S.S. "TEMPLE ARCH"

PUMPING PLAN

APPROVED
LLOYD'S REGISTER OF SHIPPING
H. R. Clayton

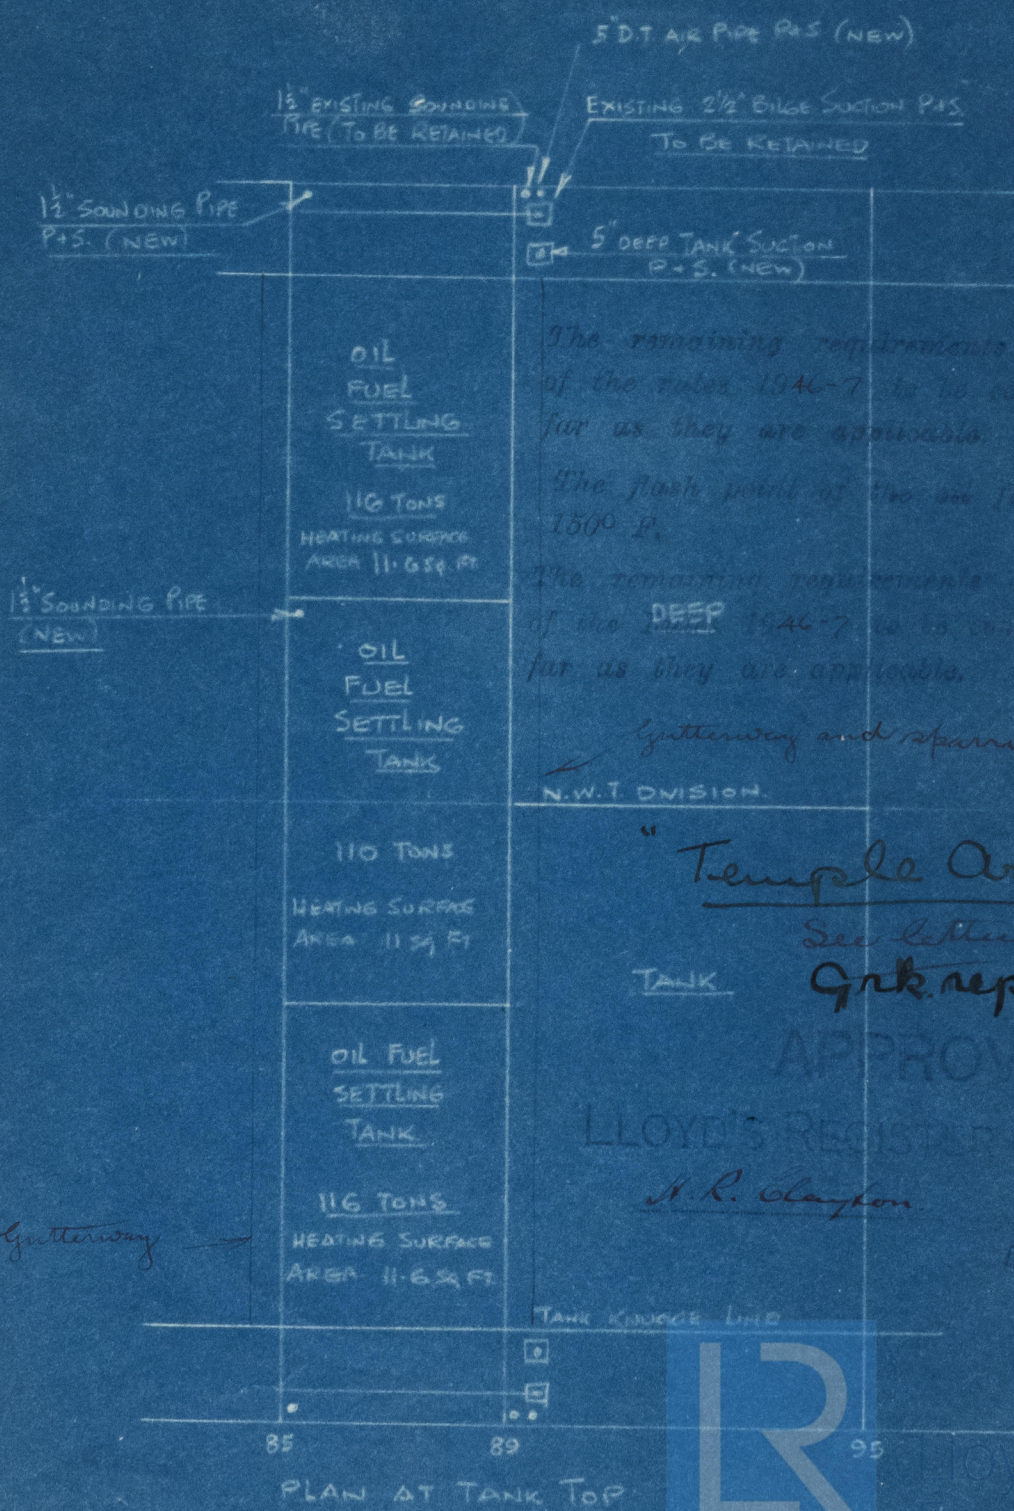
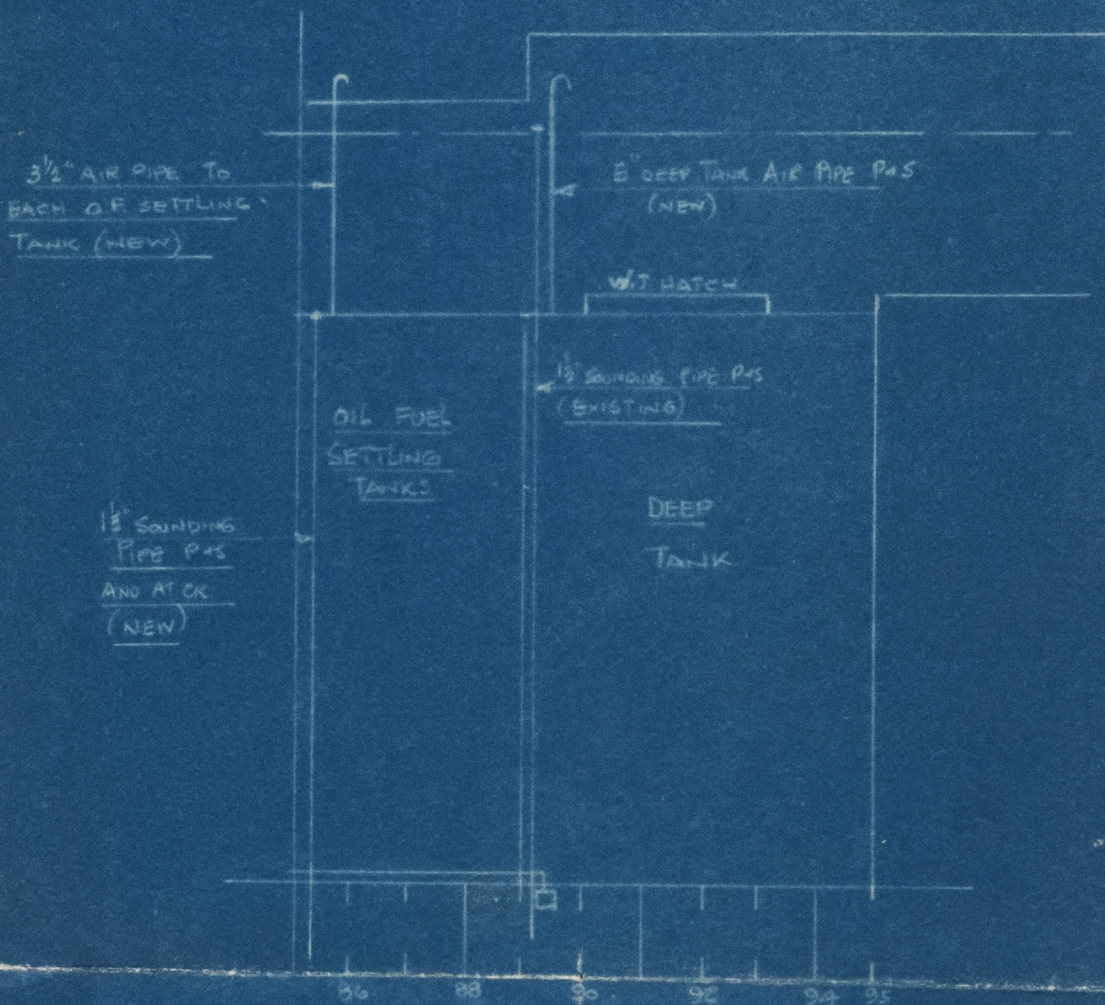
The remaining requirements of section 24
of the rules 1946-7 to be complied with so
far as they are applicable.

The flash point of the oil tank to be above
1500 F.

The remaining requirements of Section 20
of the rules 1946-7 to be complied with so
far as they are applicable.
